Project	<b>IEEE 802.16 Broadband Wireless Access Working Group</b> < <a href="http://ieee802.org/16">http://ieee802.org/16</a> >	
Title	<b>Clarification on transmitter structure for MIMO precoding</b>	
Date Submitted	<b>2005-01-22</b>	
Source(s)	Qinghua Li, Xintian Eddie Lin, Alexei Davydov, Nageen Himayat, Minnie Ho, Sumeet Sandhu, Uri Perlmutter, Yuval Lomnitz, Randall Schwartz, Jose Puthenkulam <b>Intel Corporation</b>	<a href="mailto:qinghua.li@intel.com">qinghua.li@intel.com</a> Voice: +1-408-765-9698
Re:		
Abstract		
Purpose	Adoption of proposed changes into P802.16e <del>Crossed out indicates deleted text,</del> <u>underlined blue indicates new text change to the Standard</u>	
Notice	This document has been prepared to assist IEEE 802.16. It is offered as a basis for discussion and is not binding on the contributing individual(s) or organization(s). The material in this document is subject to change in form and content after further study. The contributor(s) reserve(s) the right to add, amend or withdraw material contained herein.

# Clarification on Transmitter Structure for MIMO Precoding

**Figure 251h Illustration of Matrix C with vertically encoding for optional zones in DL.**

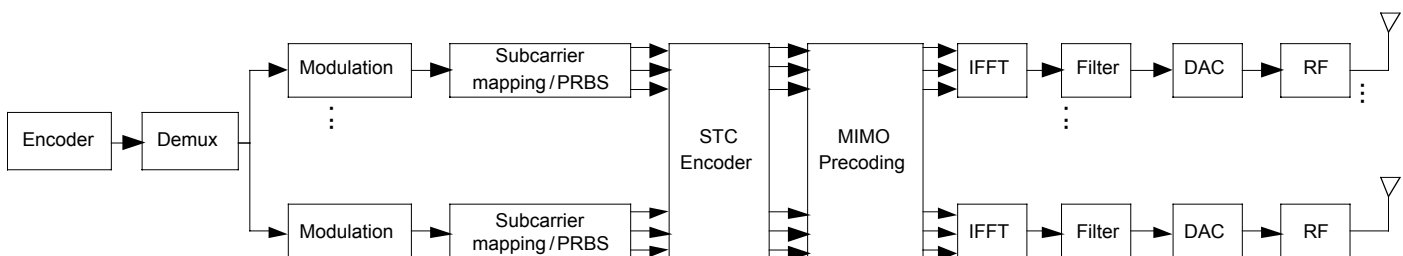
*Added at the end (i.e., line 27) in section 8.4.8.3.6 on page 344 of [1] as follows*

[In Figure 251h, the STC encoder can employ any matrixes defined in sections 8.4.8.3.3, 8.4.8.3.4, and 8.4.8.3.5 whose number of output \(i.e. rows\) is equal or less than the number of the BS antennas. The Demux assigns bits to multiple data streams according to the modulation employed by the stream.](#)
